**HISTORIC PRESERVATION REVIEW BOARD
STAFF REPORT AND RECOMMENDATION**

Landmark/District:	Anacostia Historic District	(x) Agenda
Address:	2249 Mount View Place SE	
Meeting Date:	July 27, 2023	(x) Alteration
Case Number:	HPA 23-370	() New construction
		(x) Concept

With plans prepared by Brendan Welsh of Advanced Solar, owner Daouda Lawrence seeks concept review for the installation of solar panels on a house in the Anacostia Historic District.

01 ELECTRICAL PLAN
 1/8" = 1'-0"
 0 4 8

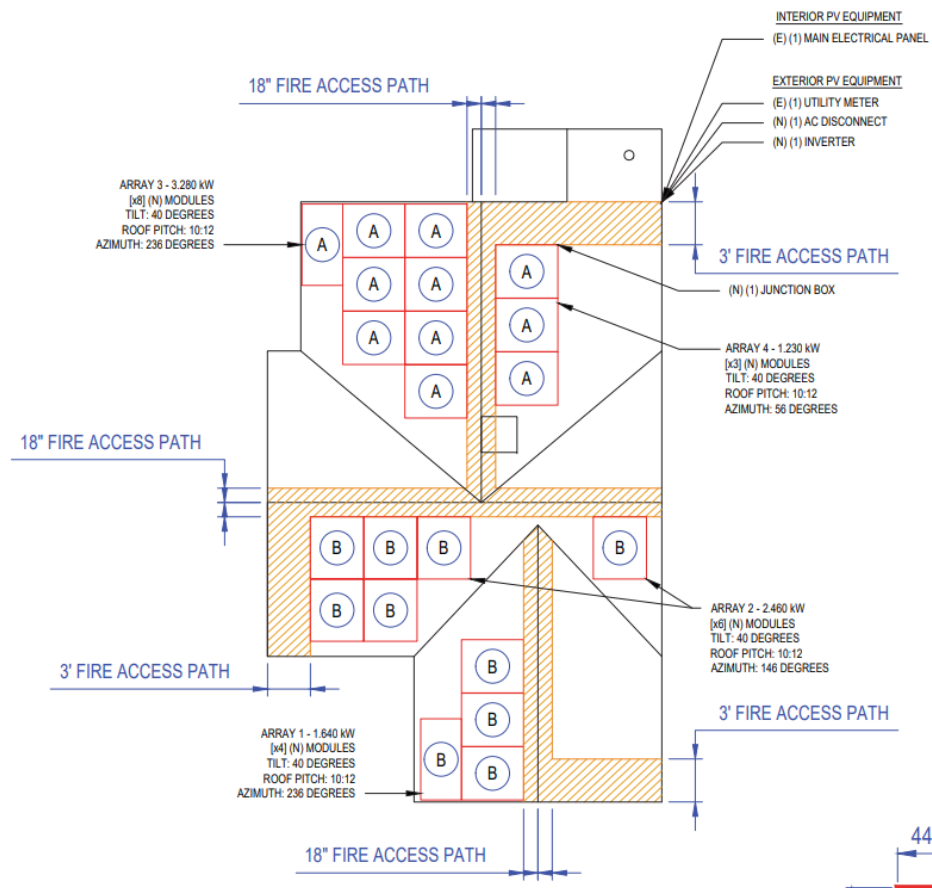
The proposed installation is not consistent with the Board's guidelines for visible solar installations. The panels would stand 6" above the roof; HPO has regularly seen installations that have a low-profile mounted no more than 4" off a roof. The color of the light color shingles and dark panels contrast with each other, the composition of the panels is unbalanced on the two elevations of the front gable and are not pulled away from the roof edge. In 2019, the Board found neighboring property, 2231 Mount View Place SE, HPA 19-292, proposed installation of solar panels to be prominently visible from streetview, and that the panels were to be pulled back to the middle of the roof to reduce their visual impact.

As with other projects review by the Board, the installation at 2249 Mount View Place may not be able to meet all of the guidelines. However, the proposal could be modified to improve its compatibility. Eliminating two panels on the west gable and relocating those to the east gable could provide a more balanced composition, provide an equal offset from the edges of the roof, and eliminate the saw-tooth composition. This alternative would be less prominently visible not as discordant with the building and streetscape. Similarly, lowering the mounting system to a maximum height of 4" - which is commonly achieved in new installations - would also ensure that the system remains tight to the roof plane.

The HPO recommends that the Board approve the installation as reasonably consistent with its standards for solar panel installations if the front panels are arranged in a more composed pattern, set back from the roof edges, and mounted lower to the roof plane as outlined above, and that final approval of the permit be delegated to the HPO.
